Attachment I

Revision 1 To Proposed
Technical Specifications Changes
Related To Low Temperature
Overpressure Protection System

New York Power Authority
Indian Point 3 Nuclear Power Plant
Docket No. 50-286

FIGURE 3.1.A-1

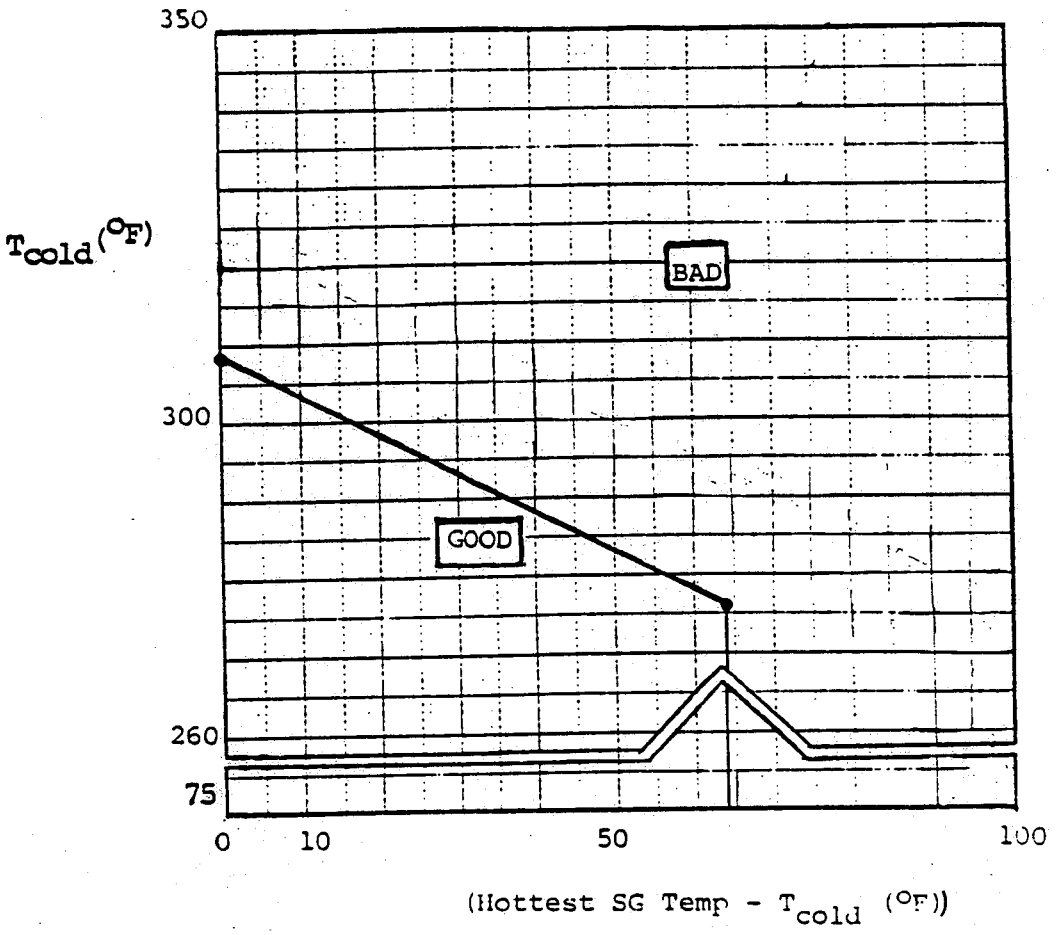
(2) The OPS is operable, the temperature of the hottest steam generator exceeds the coldest T_{cold} by no more than 64°F, pressurizer level is at or below 75 percent, and T_{cold} is as per Figure 3.1.A-1;

ure 3.1.A-2 Maximum Permissible RCS Pressure for RCP Start with OPS Inoperable

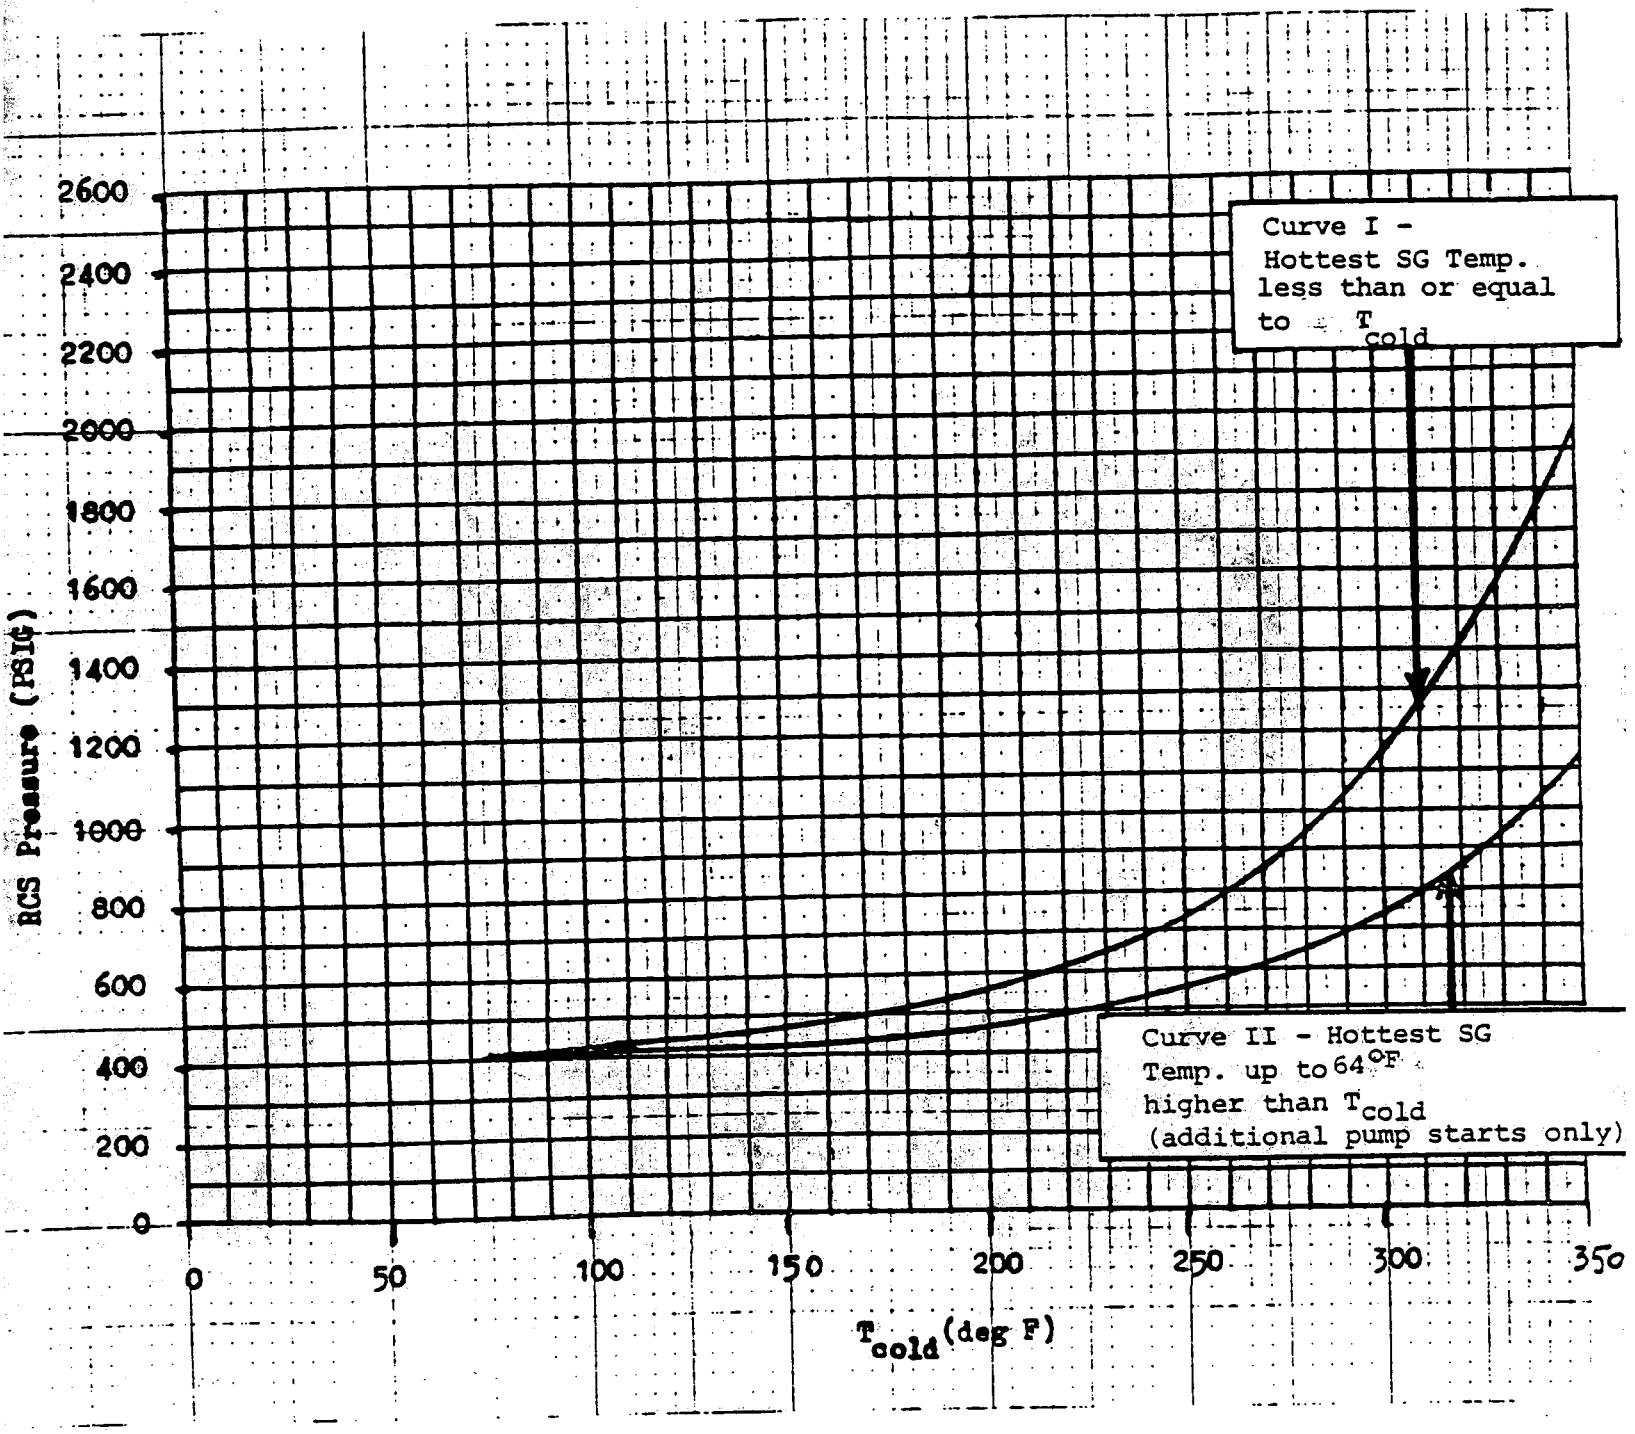
(3) The OPS is inoperable, steam generator pressure is not decreasing, the temperature of each steam generator is less than or equal to the coldest T_{cold}, pressurizer level is at or below 75 percent, and the RCS pressure does not exceed that given by Curve I on Fig. 3.1.A-2;

(1) Specification 3.1.A.1.i above may be modified to allow the OPS inoperable, providing the temperature of each steam generator has remained less than or equal to the coldest T_{cold} since the first RCP start, pressurizer level is at or below 75 percent, and the RCS pressure does not exceed that given by Curve I on Fig. 3.1.A-2.

(2) Specification 3.1.A.1.i above may be further modified to allow the OPS inoperable and the temperature of the hottest steam generator to be no greater than 64°F higher than the coldest T_{cold}, provided that pressurizer level is at or below 75 percent and RCS pressure does not exceed that given by Curve II on Fig. 3.1.A-2.

Figure 3.1.A-3 RCS Pressure Limits for Low Temperature Operation

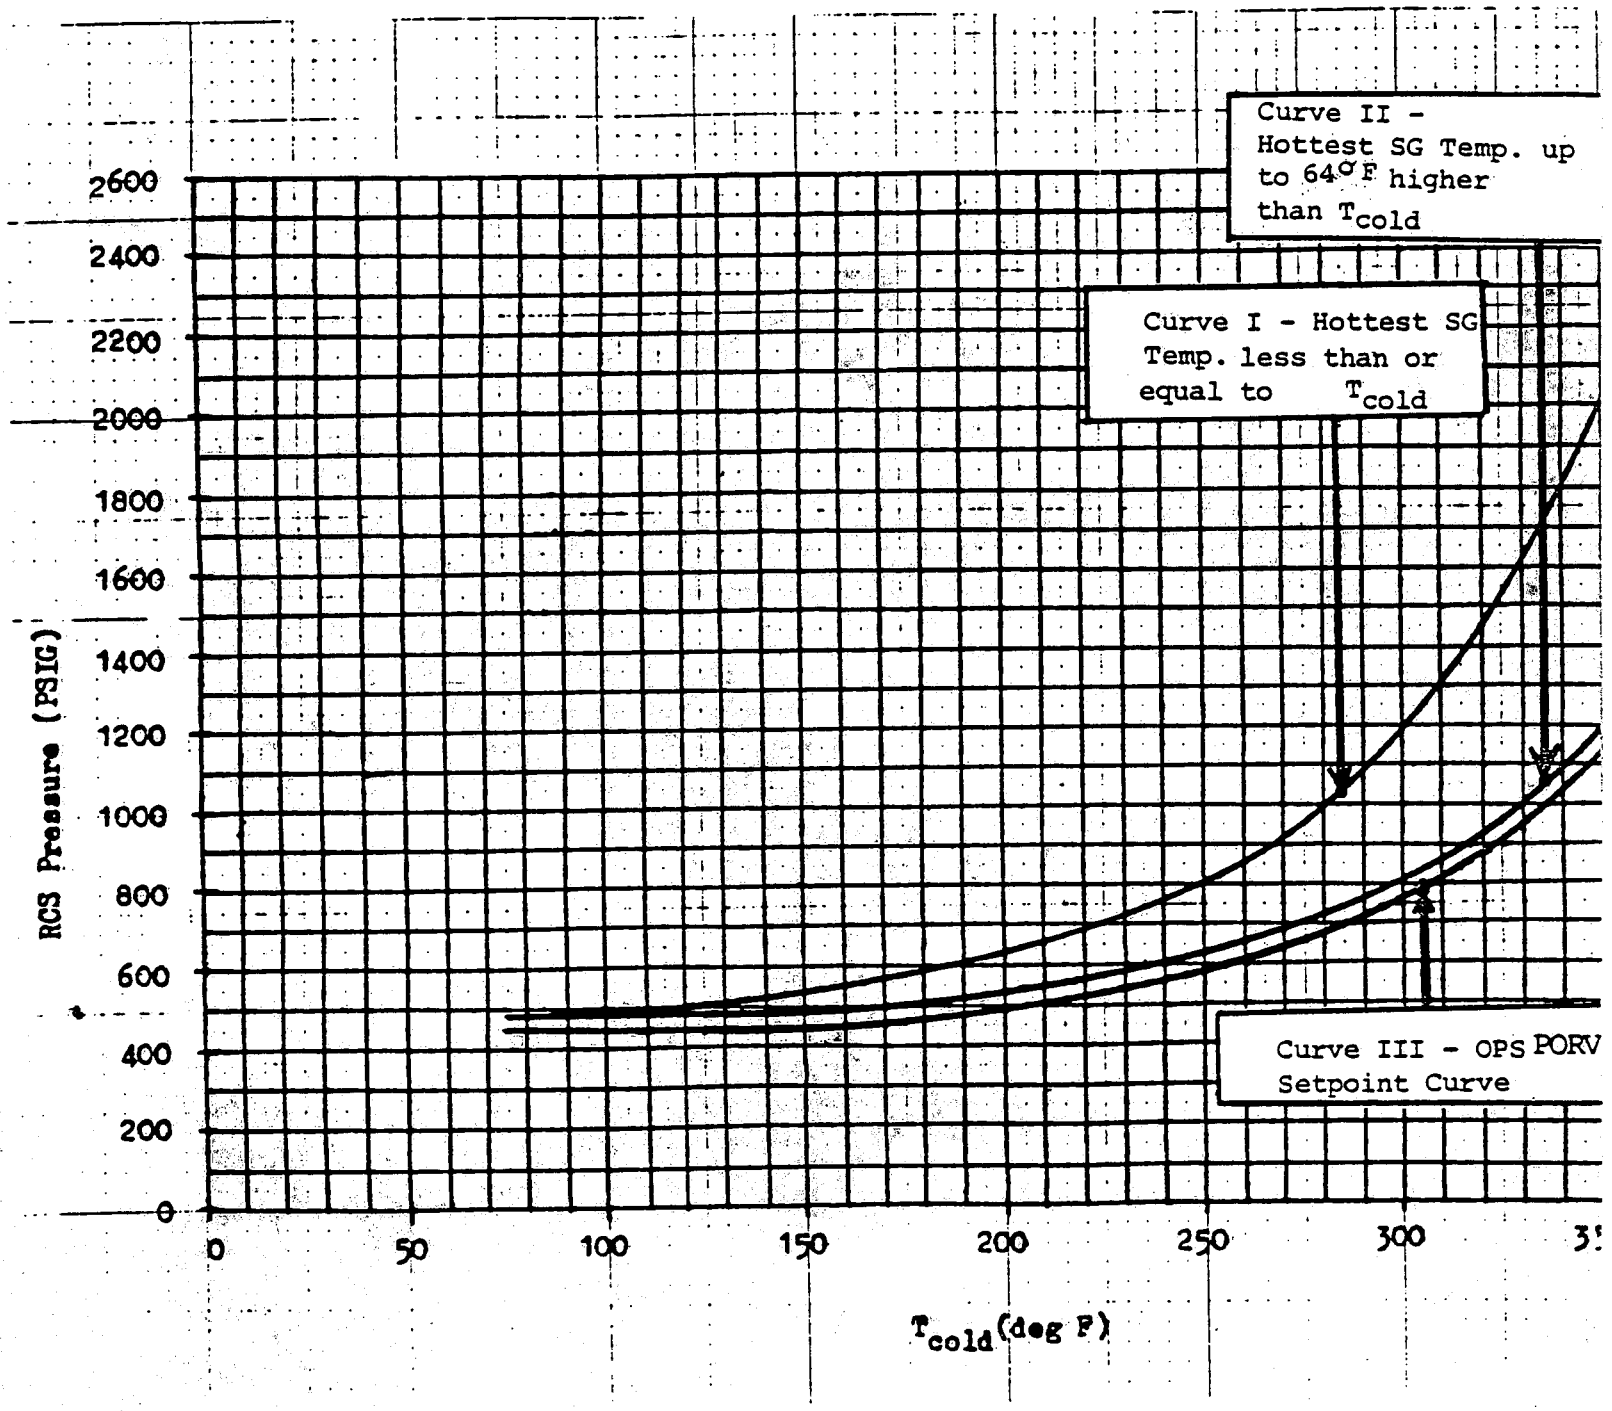
j. Following the start of one or more RCP's and prior to reaching 326°F, the RCS pressure shall not exceed that given by Curves I and II on Fig. 3.1.A-3 as appropriate.

Figure 3.1.A-4

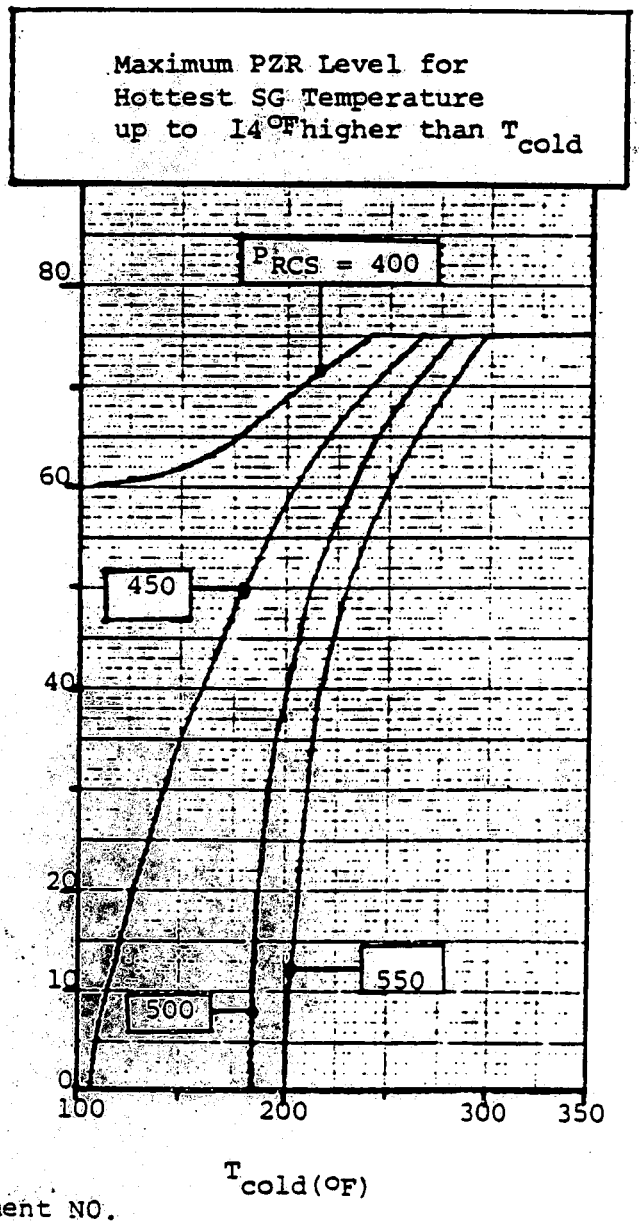
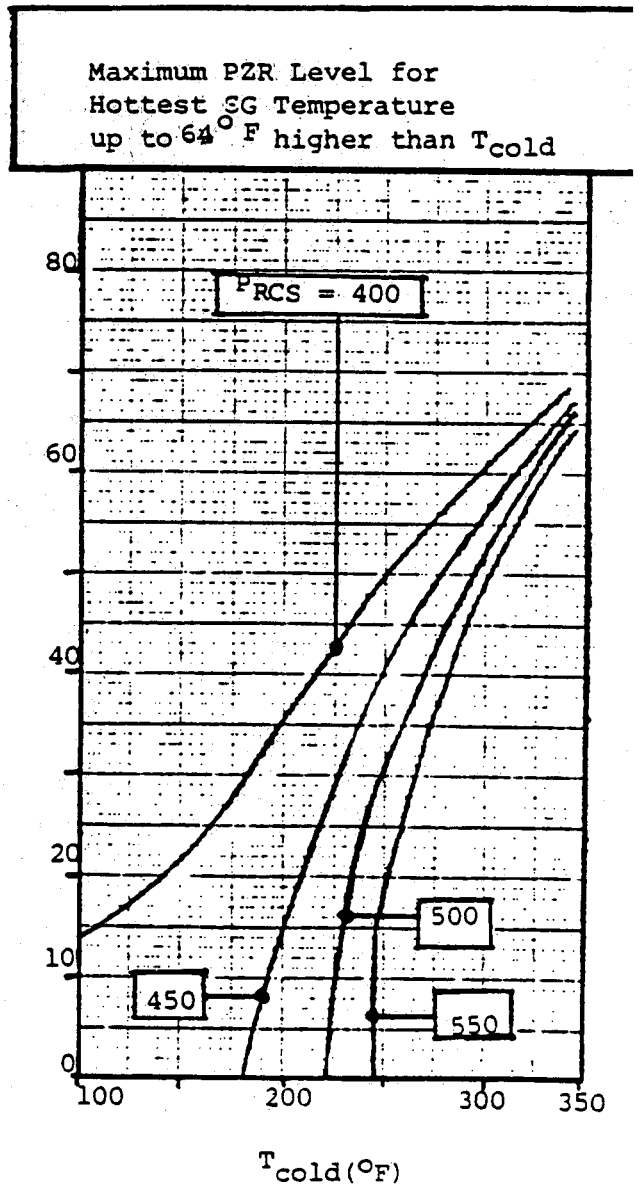
(4) The OPS is inoperable, the temperature of the hottest steam generator exceeds the coldest T_{cold} by no more than 64°F, and pressurizer level and RCS pressure do not exceed the boundaries given on Fig. 3.1.A-4.
